**TALUS PRELIMINARY PLAT
PARCELS 7, 8, 9
STAFF REPORT**

Project: TALUS Preliminary Plat, Parcels 7, 8, 9 (PP14-00001)

Request: Application for approval of a preliminary plat for Parcels 7-9 of TALUS, establishing 153 lots on 34.75 acres for single family attached and detached homes and 16 tracts for critical areas, trails, utility, access, recreation, and open space.

Parcel 7's terraced walls

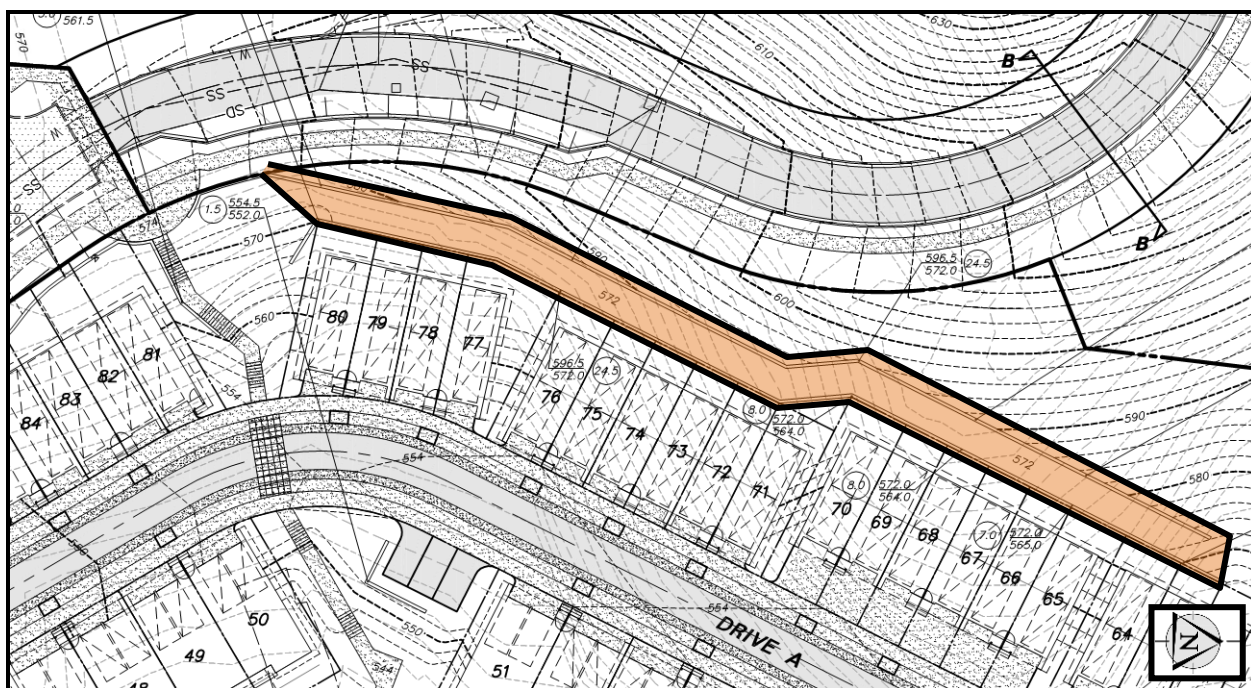
- Multiple, terraced low retaining walls should be used, and the proposed plat utilizes terraced walls in some areas such as the west side of Parcels 7 and 9.
- Low (4-10 ft), single walls are proposed in other areas such as the middle of Parcel 9 as well as the southern edge of the parcel, along Shangri-La Way; the southern edge of Parcel 8; and in the middle of Parcel 7.

- Tall walls are used frequently through this plat, for instance: 15-20 ft on the east and west sides of Parcel 9, paralleling Shangri-La Way; 10-25 ft along the north side of the Parcel 8 road and the west side of Shangri-La Way between Parcels 8 and 9; 10-25 ft along the south edge of Parcel 7 as well as 10-50 ft along the east side of Parcel 7.

In some cases these walls are tall but not located where people will be near them, i.e. they separate lots above the wall from natural open spaces areas below them. However in other cases the walls, especially the very tall ones, will be in close proximity to pedestrians, e.g. the trail along the bottom of the Parcel 7 east wall. The guidelines for walls say “When practical, terrace retaining walls to reduce bulk and to create planting areas.” Thus terraced walls shall be designed and spaced so that plantings, including trees, can be placed between them in order to provide visual relief, integrate them into the site, and reduce their visual bulk. **(Condition 7)**

Parcel 9's terraced walls

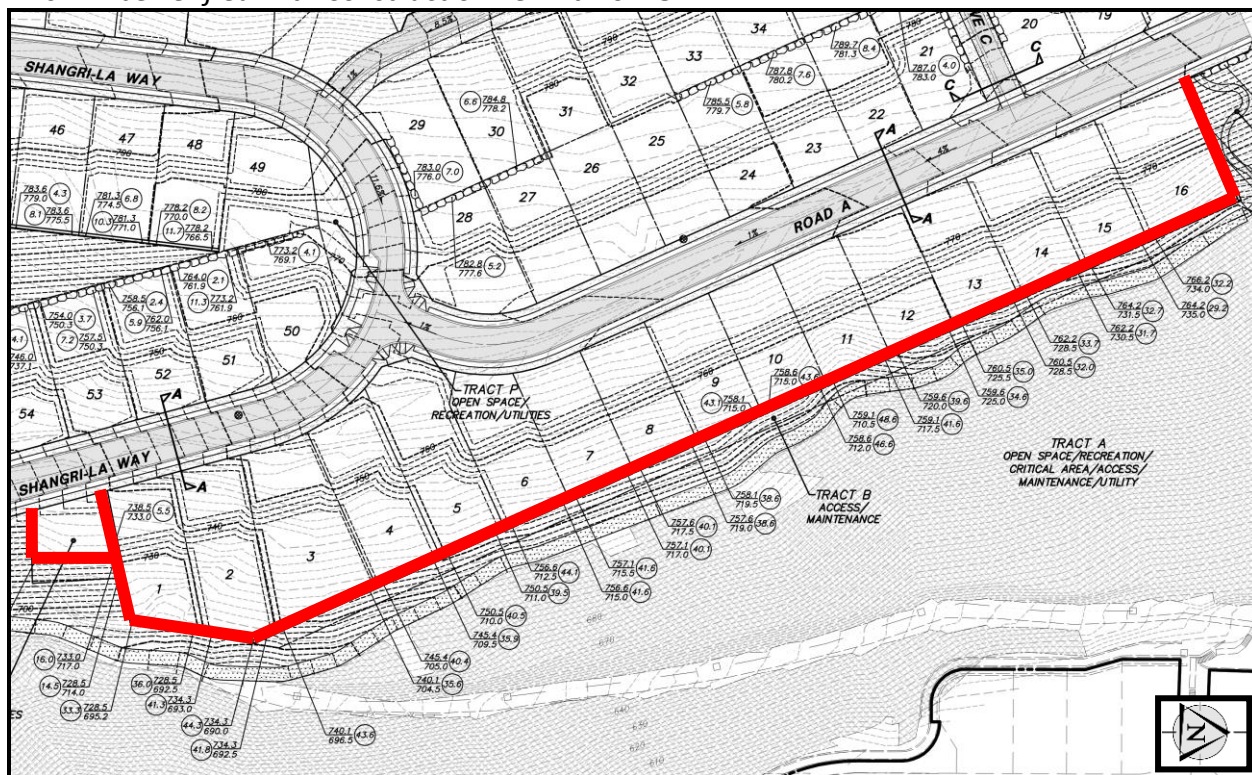
However, in some circumstances, the reason the wall is so tall is that it's chasing the slope, and terracing wouldn't reduce the wall height, you would just have a series of very tall walls. The only way to reduce the height would be to separate the parcel into more than one building pad, which would be less efficient for lot layouts, but might reduce wall heights. That does not seem practical. The guidelines also say walls need to add visual interest to the neighborhood and where large and/or tall walls are present, articulate large expanses of walls to provide visual relief and reduce visual bulk and size. In addition, where large walls are used, landscape plantings and/or artwork are employed to soften the visual effect. Thus all the walls need to be designed in ways that make them visual interesting, the larger ones are articulated, landscape material is added to provide scale when a pedestrian is nearby. A trail is proposed at the base of the wall in Parcel 7. Landscaping should be provided between the wall and the trail in order to create pleasant environment and to reduce the presence of the wall for trail users.

(Condition 8).

- 8 Where it is not practical to terrace walls, long and/or tall walls will be articulated, add visual interest to the community, and use landscape to soften the wall and transition the scale of the wall where pedestrians are nearby. For instance, at the base of the eastern wall in Parcel 7, landscaping, which includes the use of coniferous trees where feasible, shall be placed between the base of the wall and the trail in order to reduce the wall's scale and presence to pedestrians. This will be reviewed with the Wall permits and the Landscape Permit.

Parcel 7's fill wall
Open Space and Parks

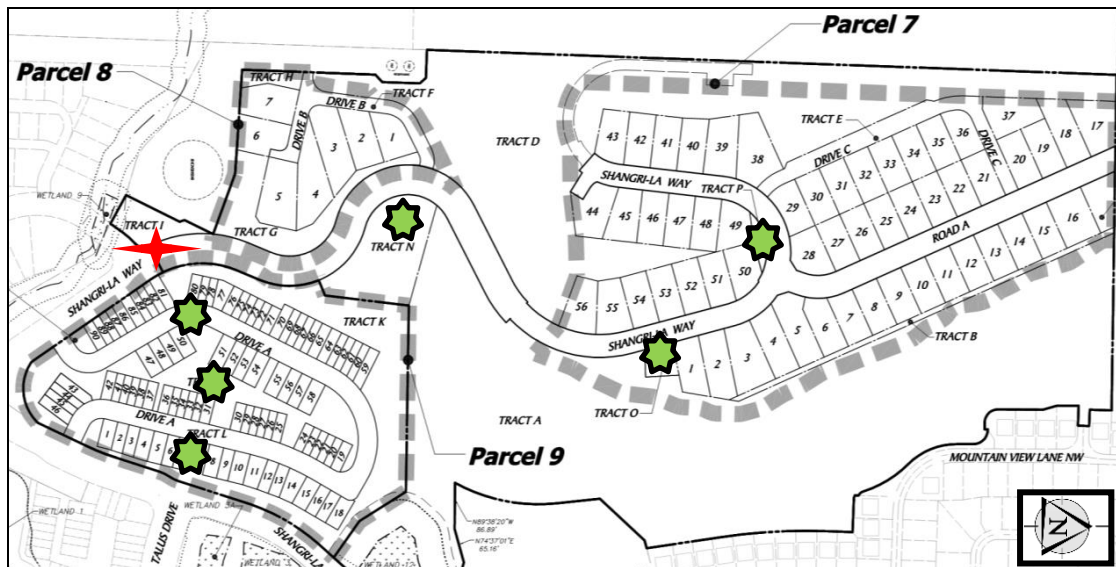
Finally, the guidelines discuss walls as being constructed of keystone, stone, rockeries, and appropriate materials. Many types of walls appear to be indicated in the plans, some walls aren't specified, and other notes indicate some existing walls are being retained, e.g. the soldier pile wall along the eastern edge of Parcel 9. Soldier pile walls are not appropriate unless they are faced with an alternative surface and all walls need to be well integrated into the site, be consistent with the character of the parcel, and make sense all together (not a hodge-podge). *This will be verified with Construction Permit No. 23.*

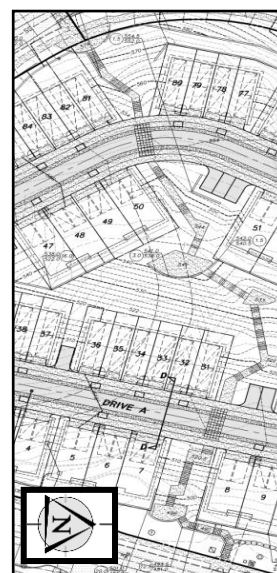
To the left: Tracts N, O, and P are located in or adjacent to Parcels 7 and 8. They will contain active recreation. Below, right: trail and overlooks through Parcel 9

As the only recreational opportunities available within these steep parcels, the spaces provided and the elements included need to offer variety and meet the many expectations for recreation, given that even where there are individual single-family detached residences, minimal if any outdoor space will be available on the lots. Thus all the spaces need to serve a wide variety of residents, including children, adults, and teens. Big toys wouldn't be appropriate as that could consume the entire space and would only serve a targeted segment of children. Instead, the grading, landscape, hardscape, etc... should serve many users. This would indicate that barbecues should not be a use, as that has limited users. Spaces designed for multiple uses, such as those shown below can serve multiple-users, and the stream is a passive use. This park/plaza has grass, plaza, benches, covered seating, climbing walls, a few individual toys/sculptures in 6500 sq.ft.

Given the limited usability of the Tract P's open space because of its steep grade, and, because of the small area of Tract O, additional recreation opportunities should be provided in Parcel 7. See Appendix L for further discussion.

Drive B: Parcel 8 – Residential Street

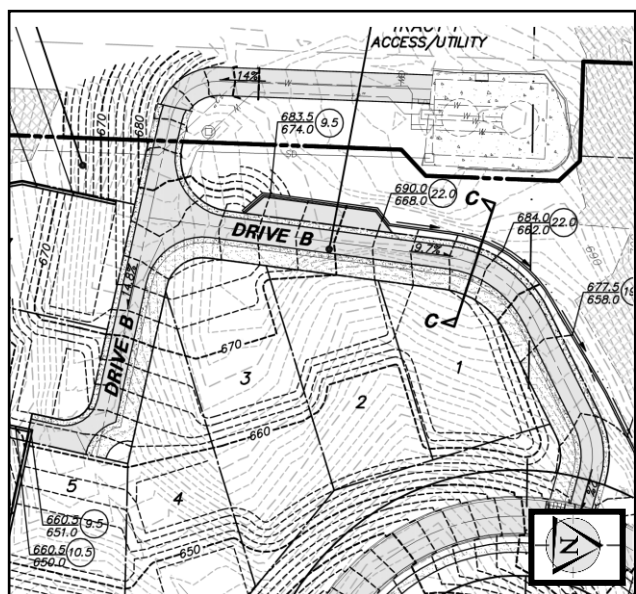
Drive B: Drive B, serving Parcel 8 is designed as a Residential Street per Appendix F. The sidewalk has been removed on the west side of the street where residences are not present per AMM14-00002. The road rises in elevation approximately 30 feet (up to 15% grade) from the intersection with Shangri-La Way to its highest service point at the hammerhead turnaround for Eastside Fire and Rescue access adjacent to Lot 7. A short section of road will continue to the north and west and will provide access to the existing 752 Reservoirs. Because of the steep grades in Parcel 8, the amount of on-street parking that can be accommodated is limited to the section of street to the west of Lots 2 and 3.

The approval of AMM14-00002 requires that between 31 and 38 feet of width be provided within Tract F in order to accommodate the road, sidewalk, planters and parking. The application specifies only 26 feet of width for these elements. Compliance with AMM14-00002 will require additional width for the planters and sidewalk. This will be verified with the site work permits and the Final Plat. **(Condition 17)**

- 17 Per AMM14-00002, the Parcel 8 road and Tract F (Drive B) must be widened as necessary in order to provide sidewalk and planter facilities. This condition will be verified with the Final Plat.
